SERVICE BULLETIN K4900 SERIES
VERTICAL DEFLECTION CIRCUIT REVISION

All K4900 Series Monitors including, but not limited to, the following model numbers:

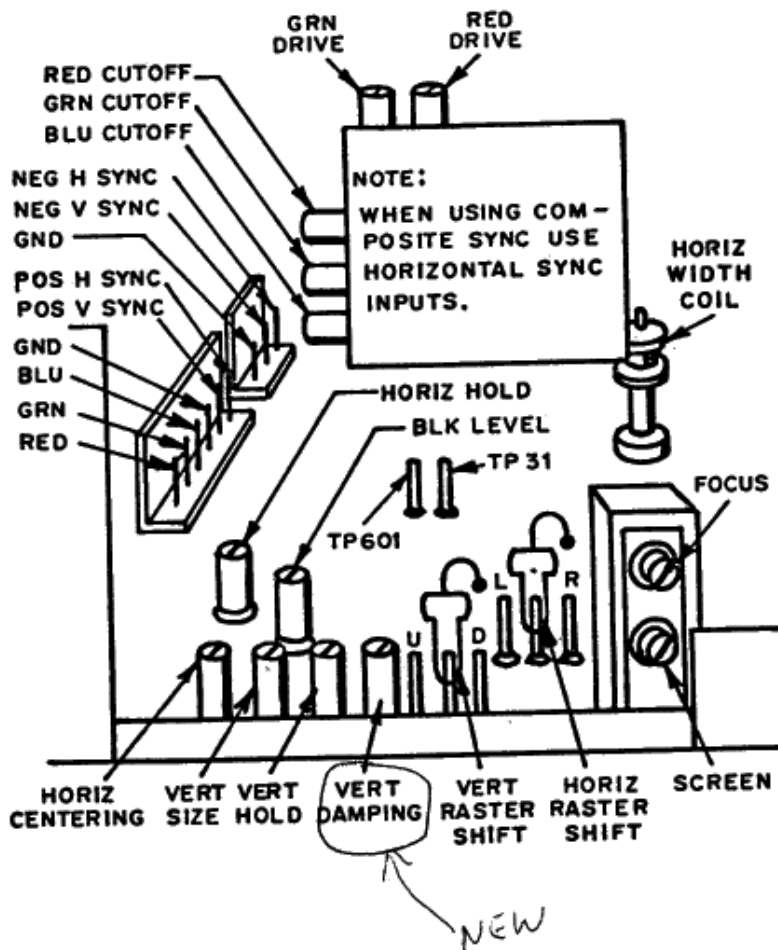
- The model number on the shipping carton and on the monitor is printed in red.
- The part number on the deflection yoke is either 2021111258 or 2021111264.
- The flyback transformer stabilizing bracket is labeled 611X0005-008.
- There is an additional control, the VERTICAL DAMPING CONTROL shown above immediately to the right of the Vertical Hold Control.

The applicable monitors have an improved deflection yoke which provides for faster vertical retrace. This permits more lines of video to be displayed. The VERTICAL DAMPING CONTROL permits the user to adjust the uniformity of spacing of the additional lines.

The adjustment of the VERTICAL DAMPING CONTROL is important only if the vertical size is adjusted such that the additional lines appear on the screen. Turn up the Black Level Control such that the raster lines can be seen. Adjust the Vertical Damping Control such that the top raster lines are spaced uniformly and not folded over. Return the Black Level Control to the desired setting.
